# Access Compliance Report

## Public Rights-of-Way

### (Curb Ramps)

Intersection ID: 10020376	Main Street: BALLANTYNE CORPORATE PL	Cross Street: N/A	Location: NE
ADA ID: F32E843FAFCB	Ramp Type: BlendTrans2	Initial Pass/Fail: Fail	Overall Compliance: No
Severity Score: 12.5			
Codes/Mitigation Info/Possible Solution		Field Measurements/Component Compliance

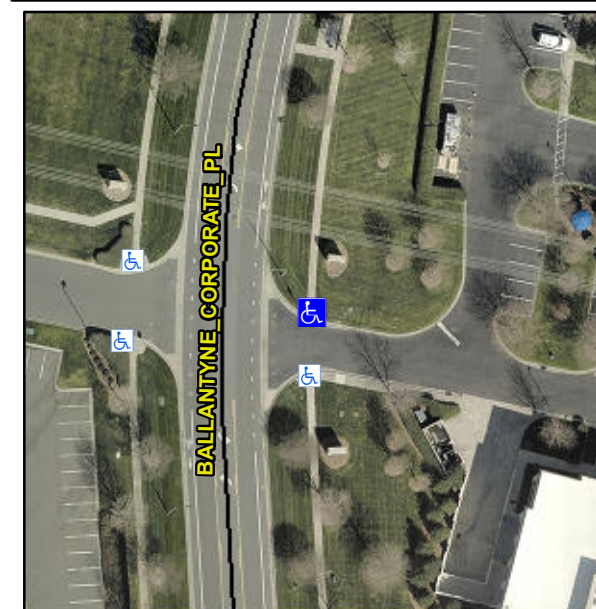
Compliance	Description	Data	Compliance	Description	Data
N/A	Ramp Length (in)	77.0	Yes	BlendTrans Slope (%)	2.5
Yes	Ramp Width (in)	48.0	No	BlendTrans XSlope (%)	5.5
N/A	Flare Type LT	N/A	N/A	Flare Type RT	N/A
N/A	Flare Slope LT (%)	N/A	N/A	Flare Slope RT (%)	N/A
N/A	Flare Traversable LT?	N/A	N/A	Flare Traversable RT?	N/A
N/A	Landing Length (in)	N/A	N/A	DWS Provided?	N/A
N/A	Landing Width (in)	N/A	N/A	DWS Contrast?	N/A
N/A	Landing Slope (%)	N/A	N/A	DWS Length (in)	N/A
N/A	Landing X Slope (%)	N/A	N/A	DWS Full Width?	N/A
N/A	Landing Curb? (Y/N)	N/A	N/A	DWS Offset (in)	N/A
N/A	Shared Landing?	N/A			
N/A	Gutter Ponding?	N/A	N/A	Gutter Slope (%)	N/A
N/A	Gutter Lip Ht (in)	N/A	N/A	Gutter X Slope (%)	N/A
N/A	Painted X Walk1?	No	N/A	Painted X Walk2?	N/A
	X Walk 1 Direction	To S		X Walk 2 Direction	N/A
	X Walk 1 Width (in)	N/A		X Walk 2 Width (in)	N/A
	X Walk 1 Slope (%)	2.6		X Walk 2 Slope (%)	N/A
	X Walk 1 X Slope (%)	3.1		X Walk 2 X Slope (%)	N/A

N/A	Ramp inside XWalk1?	N/A	N/A	Ramp inside XWalk2?	N/A
	Road Slope (%)	3.1		Clear Space?	N/A
	Road X Slope (%)	2.6	N/A	Clear Space to XWalk (in)	N/A
N/A	Any Obstructions?	N/A	N/A	Storm Grate/Utility Hazard?	N/A
	Obstruction Type			Storm Grate/Utility Type	
		N/A			N/A
			Yes	Surface Condition? (G/P)	Good
			N/A	Curb Slope (%)	0.0

**Remove & Replace Curb Ramp With Two New Directional Ramps or Equivalent.**

**R304.5.3**
